PROJECT:
NEW CONSTRUCTION
TACO TIME
1115 EAST MAIN STREET
PUYALLUP, WA 98372

DATE
7.1.2022
BCRA NO.
19110.00.00
DRAWN BY:
REVIEWED BY:
SHEET TITLE
EXTERIOR
ELEVATIONS

1 NORTH ELEVATION

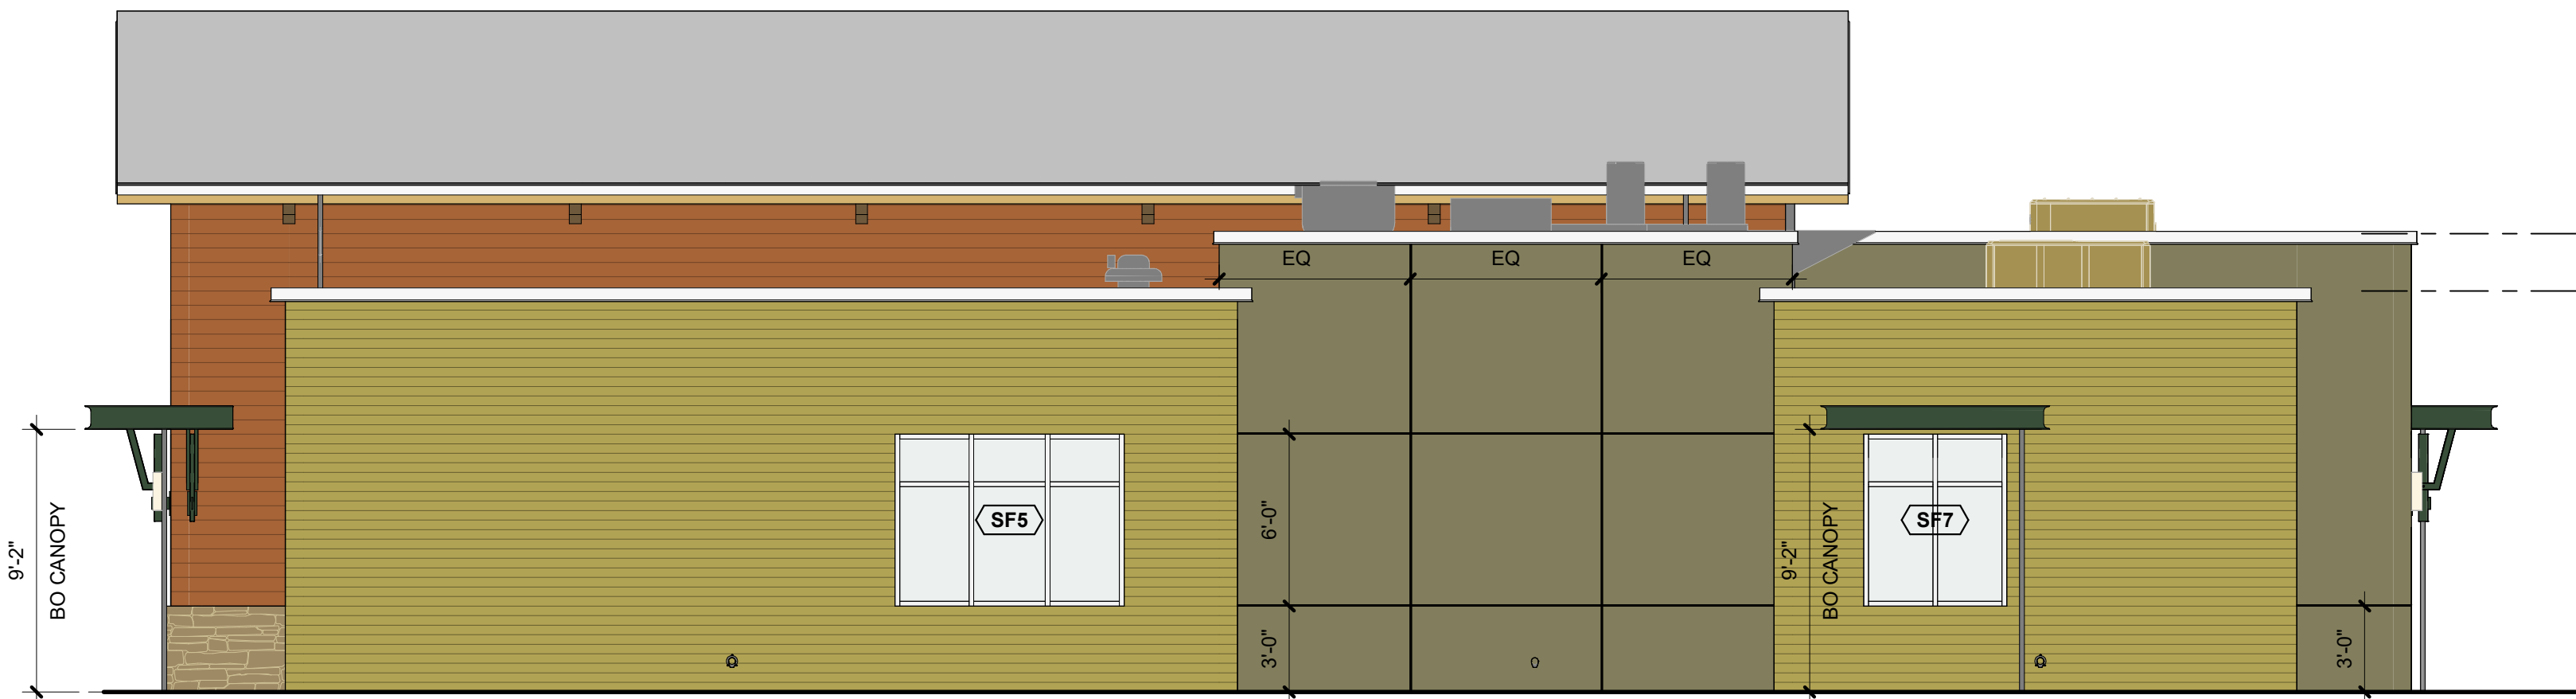
The plans show the awning only part of the required plaza area. The pedestrian-oriented plaza is required to be covered by awnings covering at least 6' of the plaza space and run the full width of the front of the building as well. a. Please extend the awning to extend at least 6' over the 8' pedestrian-oriented plaza and run the full length of the front of the building.
PMC 20.26.300 (3)(b)(i) A pedestrian-oriented plaza space in front of the building at least eight feet deep running the full width of the building. This area shall be covered by awnings covering at least six feet of the plaza space. This plaza space shall include amenities such as bike parking, bench seating, planters, fountains, artwork, decorative railing, decorative light fixtures, hanging baskets or other features that are pedestrian scaled in nature; [elevations, pg. 1]

The surface area of the street-facing wall must consist of at least 60% windows and/or transparent doorways. In your design review narrative, you state that 53% of the street fronting façade is glazed from 2'-8" above grade. Please resubmit elevations with the street-facing wall consisting of at least 60% windows and/or transparent doorways and include the calculations of this percentage on the elevation plans.
PMC 20.26.300 (3)(d) Building Entrances and Design. At least one building entrance for an individual building (or individual tenant spaces) shall face each public street frontage or be located within 50 lineal feet from a public street frontage. Directly linking pedestrian access shall be provided between the street right-of-way and each building entrance. No less than 60 percent of the surface area of any street-facing wall shall consist of windows and/or transparent doorways. [elevations, pg. 1]
